**COUNCIL ASSESSMENT PANEL MEETING  
8 July 2020**

**AGENDA – 9.2**

<b>Applicant:</b> David Freschi	<b>Landowner:</b> D E & T L Freschi
<b>Agent:</b> N/A	<b>Originating Officer:</b> Sam Clements
<b>Development Application:</b>	20/321/473
<b>Application Description:</b> Variation to Development Authorisation 17/262/473- to vary conditions 5 & 8 pertaining to capacity, number of functions & hours of operation, to include toilet block & store room additions onto the cellar door, to amend the deck to freestanding and increase the area of deck & to make alterations to the car park	
<b>Subject Land:</b> Lot:2 Sec: P978 FP:130666 CT:5756/921	<b>General Location:</b> 159 Ridge Road Ashton  <b>Attachment – Locality Plan</b>
<b>Development Plan Consolidated :</b> 8 August 2019 <b>Map AdHi/3</b>	<b>Zone/Policy Area:</b> Hills Face Zone
<b>Form of Development:</b> Merit	<b>Site Area:</b> 15.98Ha
<b>Public Notice Category:</b> Merit Category 3	<b>Representations Received:</b> 1

SHEET: 2 of 5  
SCALE: 1:100 (A3)  
DATE: 3 -2020

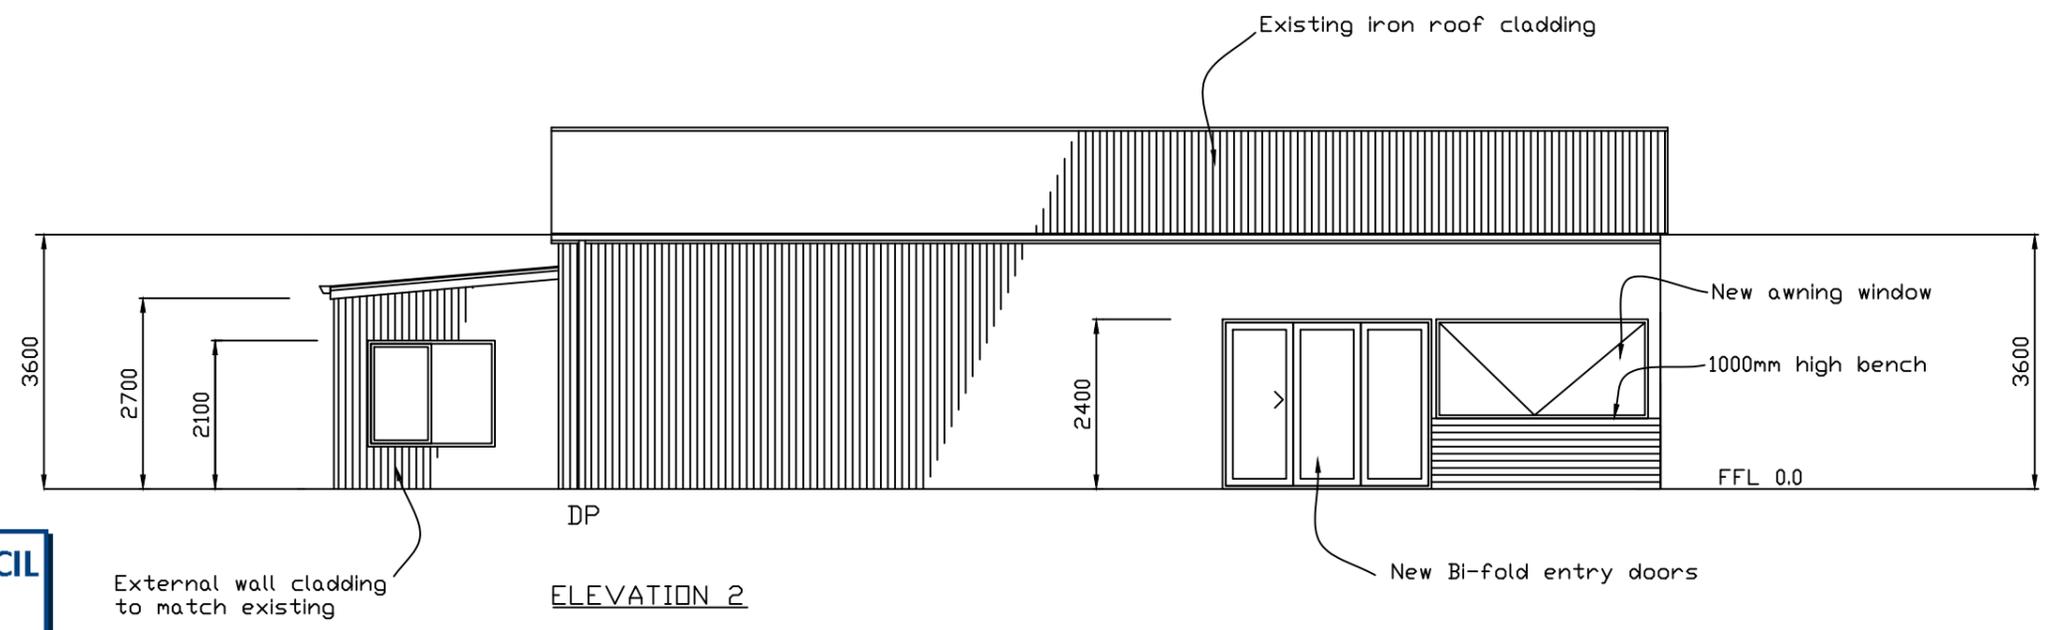
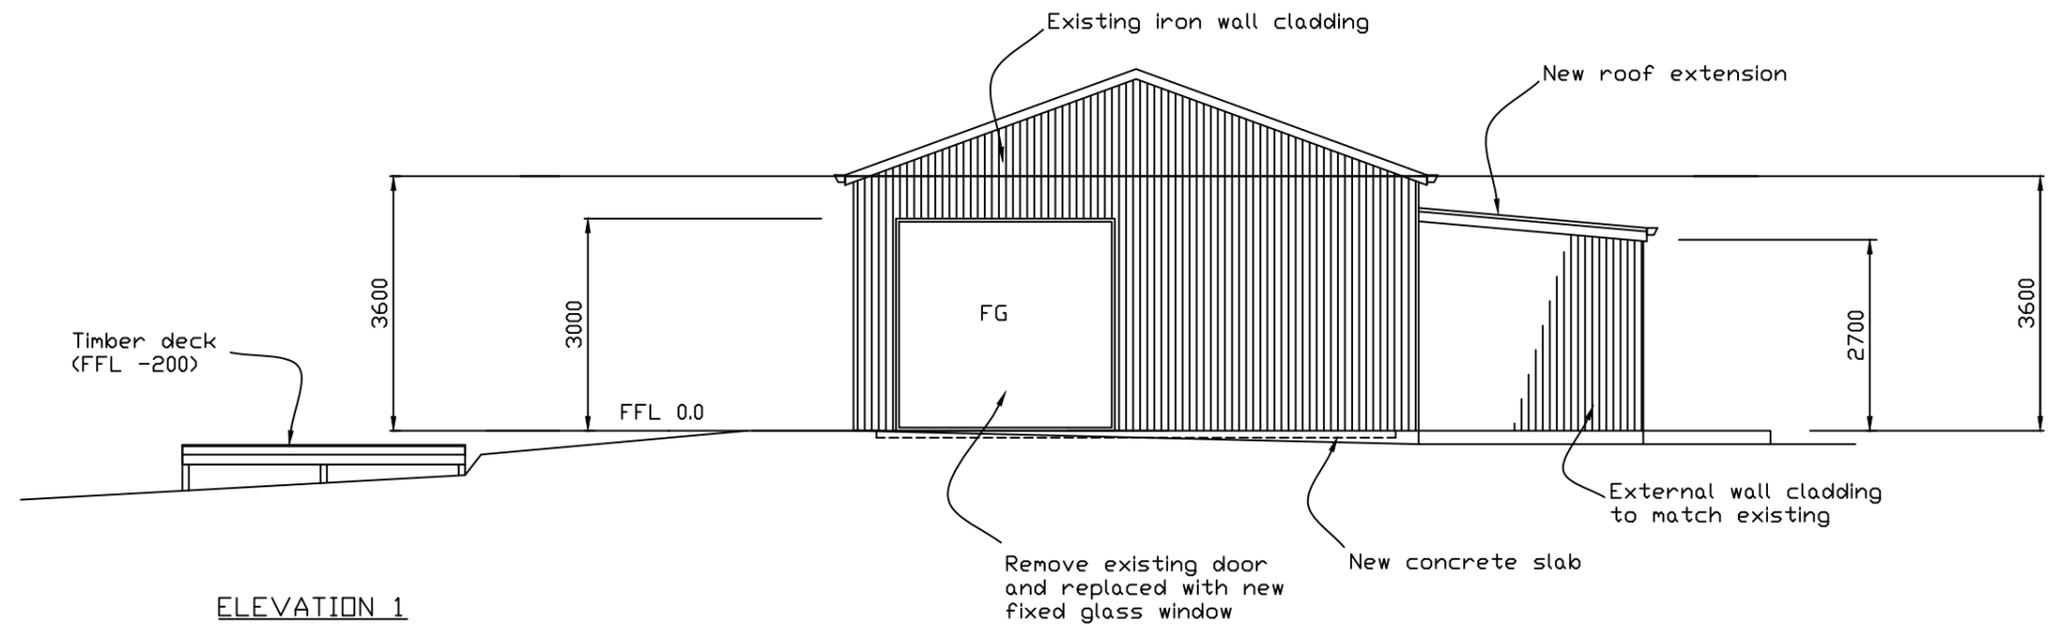
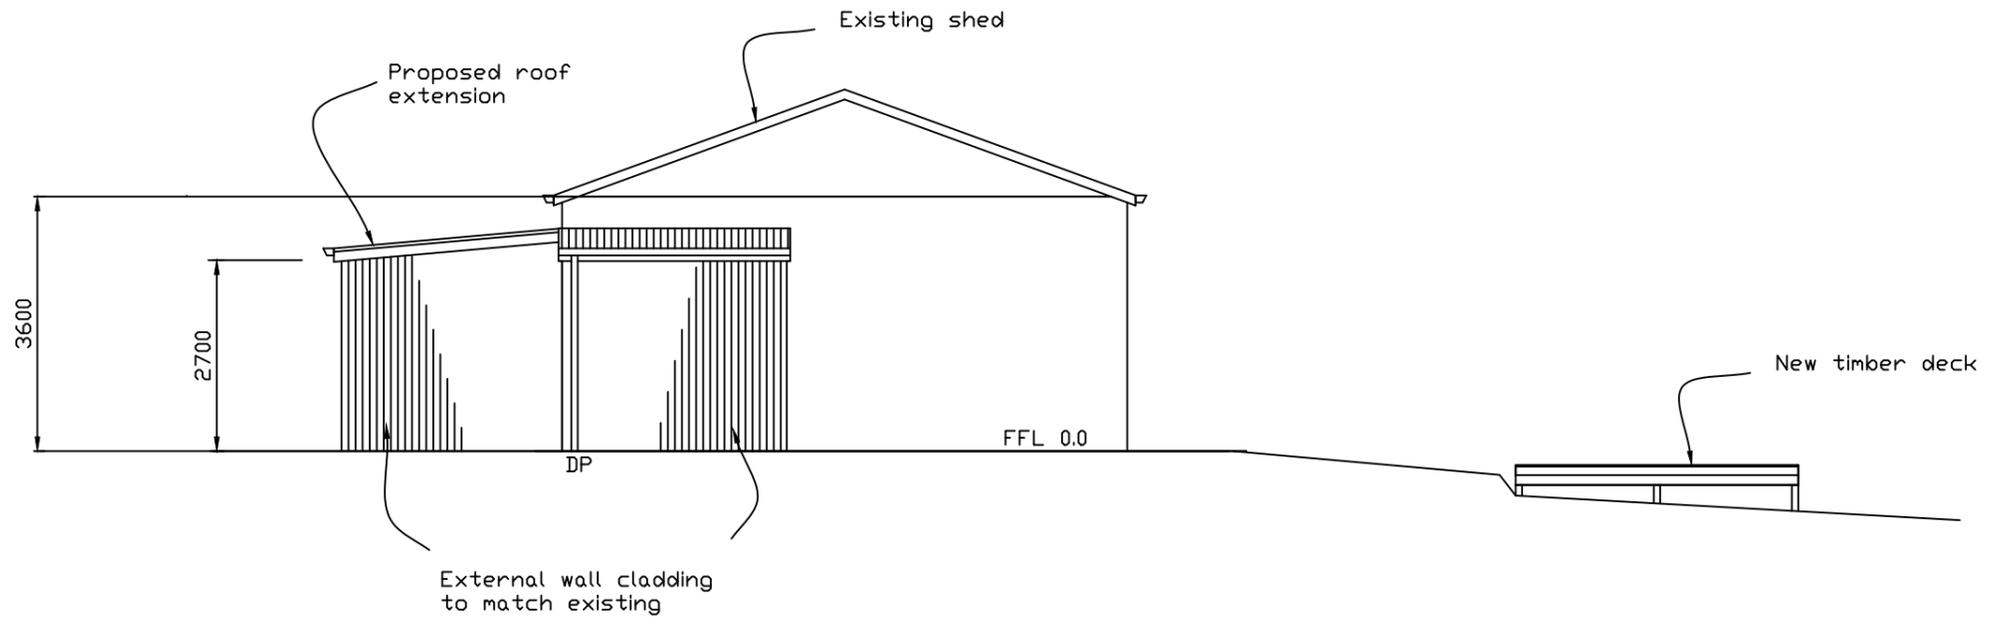
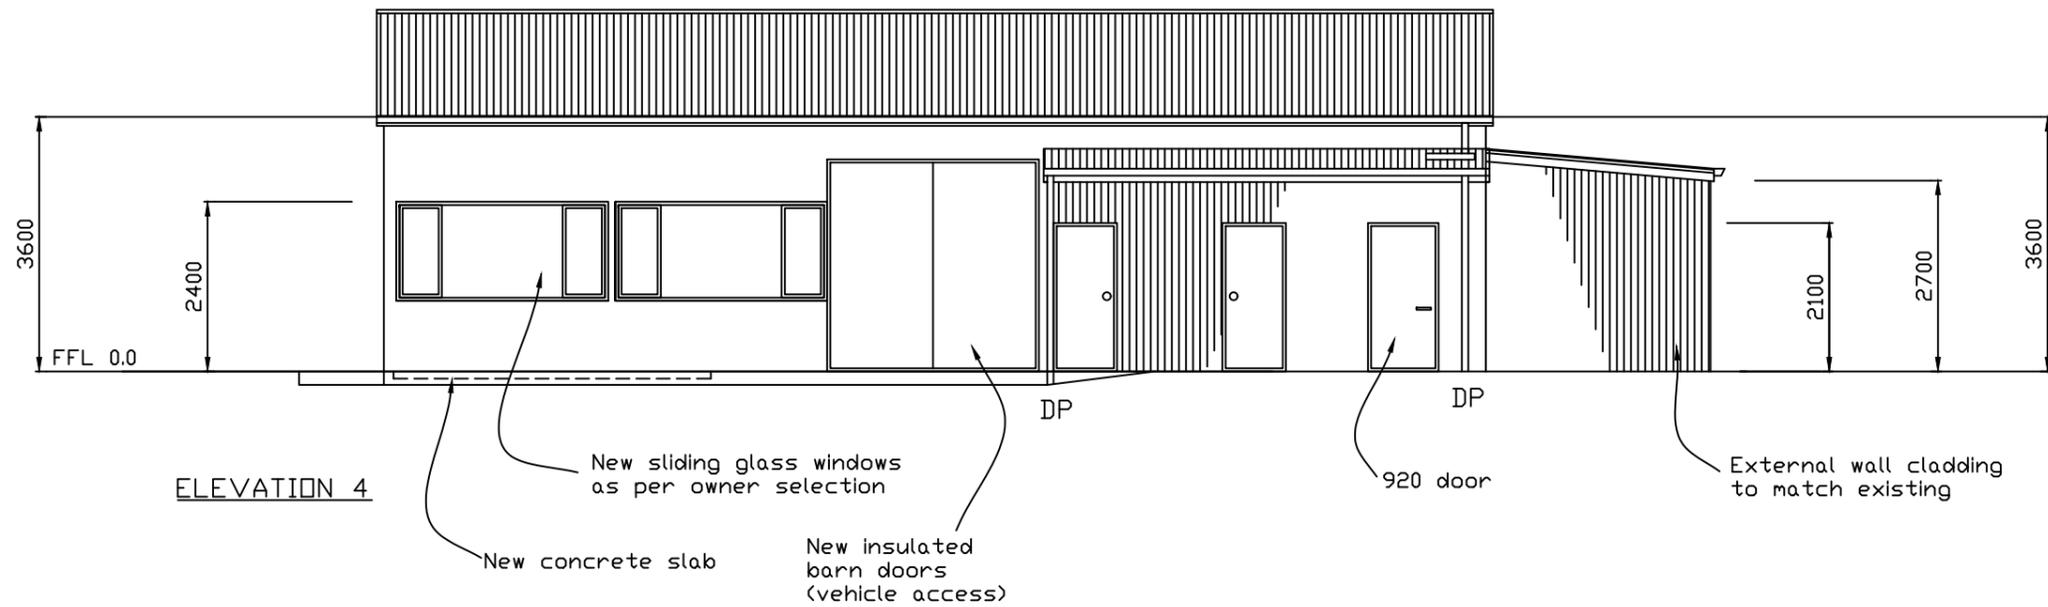
- Changes to the building alterations, namely a sliding door on the north elevation increased in width (double glass doors to triple bi-fold doors) and on the southern elevation inclusion of an additional glass sliding window and relocation of the double insulated barn doors
- A small addition to the authorised cellar door to provide dedicated toilets and a store room. The authorised cellar door did not include nor was it a requirement under the Building Code of Australia (BCA) to provide toilets or wash basin (just a portaloos) as it was limited to 20 persons

**CAPTIONS IN RED  
BY KYM NITSCHKE**

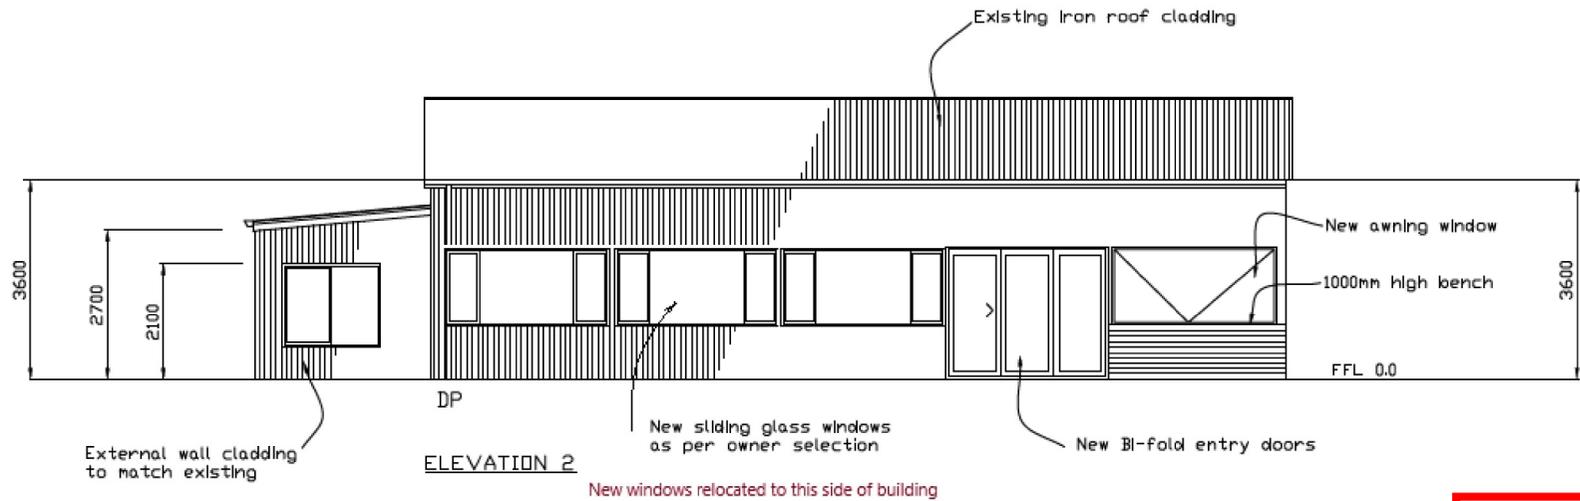
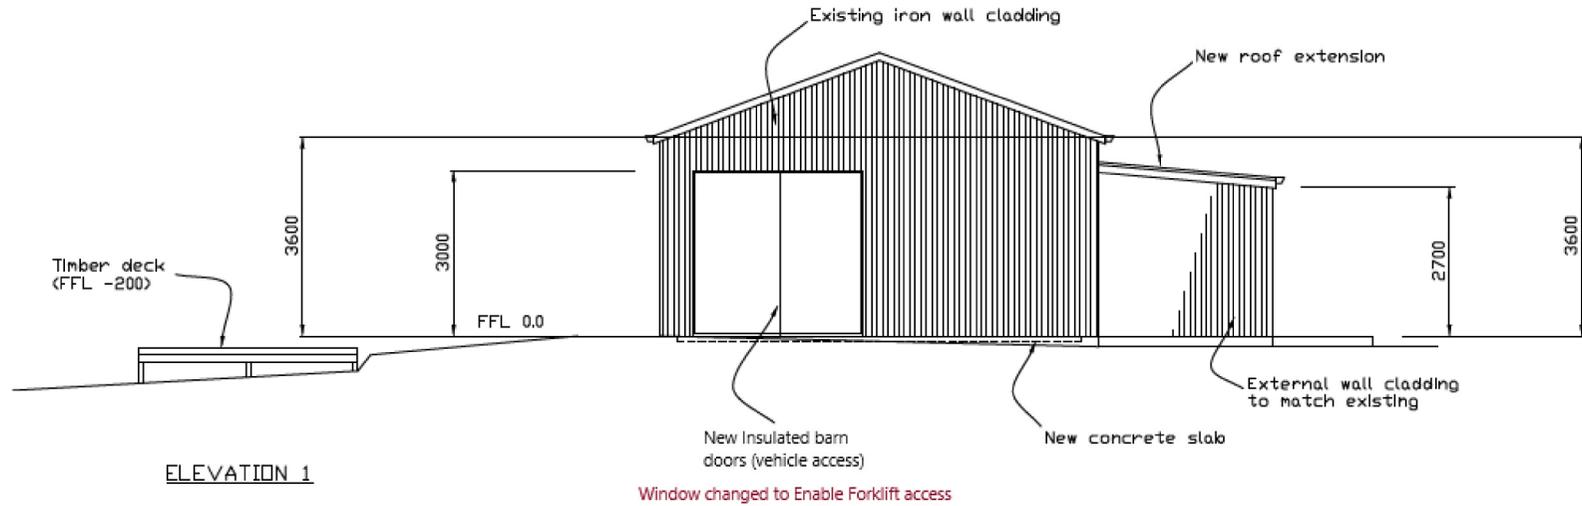
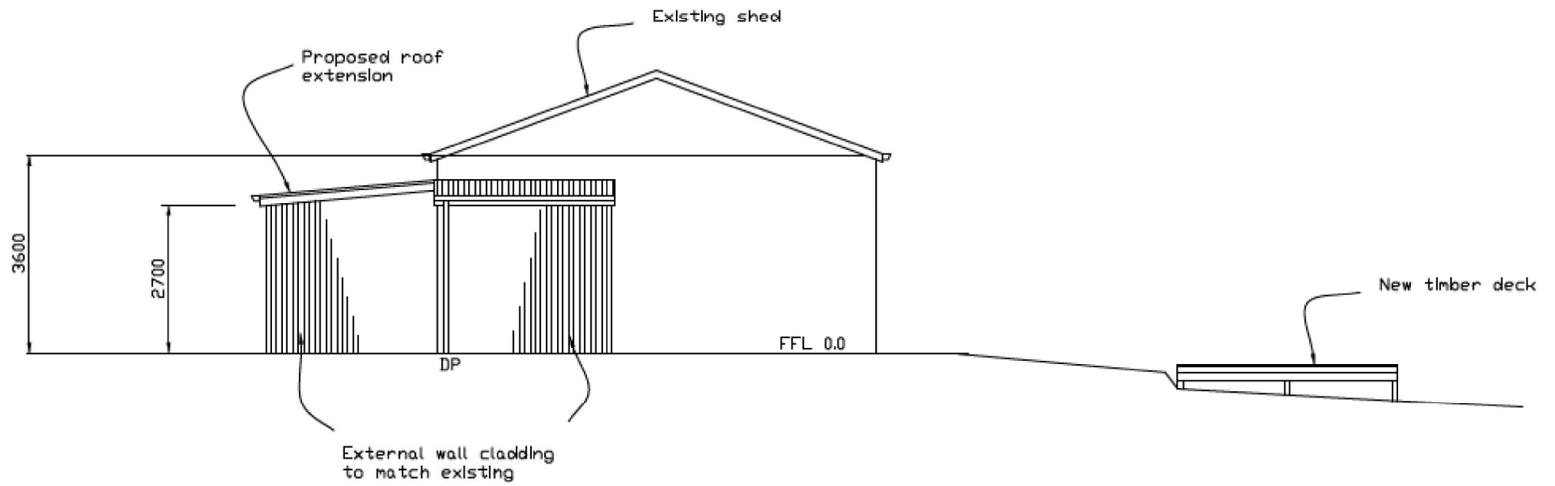
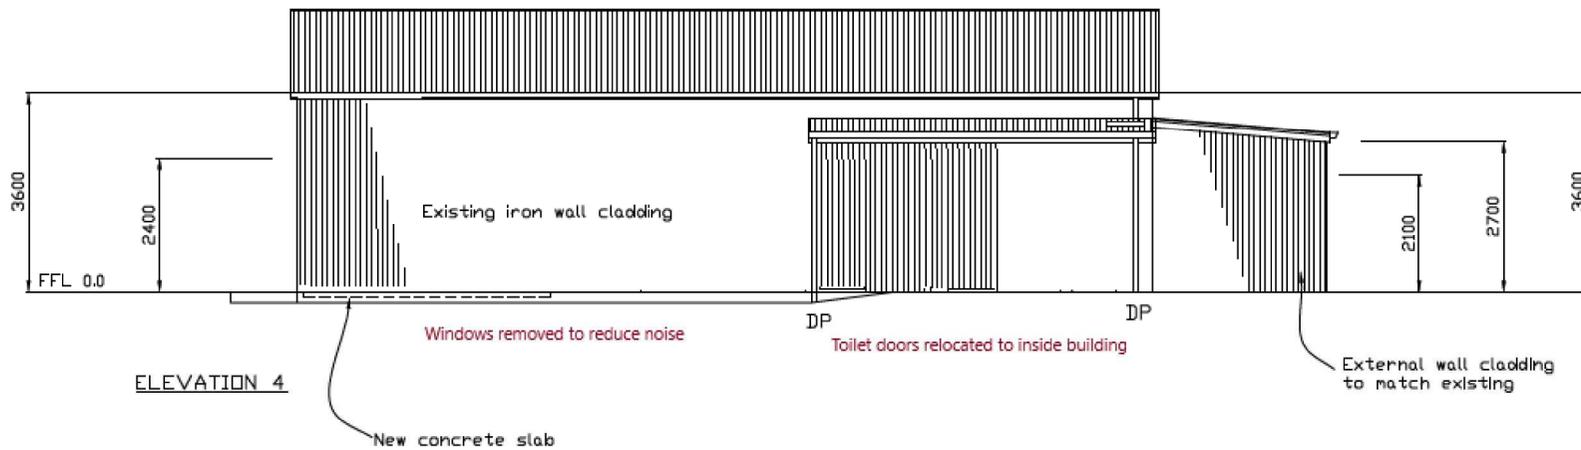
The property at 141 Ridge Rd, Ashton is the one most affected by the proposed development. The kitchen window looks directly at the shed at 159 Ridge Rd. Due to the contours of the landscape, the site represents a natural amphitheatre. This results in any sound made in the shed becoming amplified and entering the kitchen window at full volume. The applicant has suggested that the property is screened by trees but this is inadequate. See the photo of the shed taken recently from the property at 141 Ridge Rd. There is a line of trees planted along the border of the two properties however, they are planted a long way apart and so there are massive gaps between the trees. It should also be noted that the trees are deciduous so for half the year the trees have no leaves on them and they offer no screening at all.

The applicant plans to modify a shed and install toilets and a coolroom on the edge of a paddock which is extremely picturesque and possesses natural landscape character. These items will detract significantly from the visual amenity of the region and affect residential amenity and the community atmosphere.

**Encl- 1 photo of the site and a 3 marked up plans by Kym Nitschke.**

The alterations additionally address disabled access and facilities, and effluent management (see recently submitted waste management report by Maxwell Engineering). The only other change to our proposal is the addition of a small store room/office, hidden on the east side of the building, a slight increase to opening hours and number of functions, and the relocation of the deck area, out of site from the Nitschke house.

**Loss of amenity:** (DF) In response to the comment that they will be able to view the cellar door from their kitchen window resulting in a loss of amenity, I again reinforce the distance between the two properties, the poplar screen between them, and that the photo provided is not a true line of sight from the Nitschke kitchen window.

(DF) The change in location of the deck to the previously designated grassed area with tables and chairs maintains the minimization of any adverse noise impact. It is also located over the ridge line, out of sight, facing in the opposite direction (north) away from the Nitschke house.
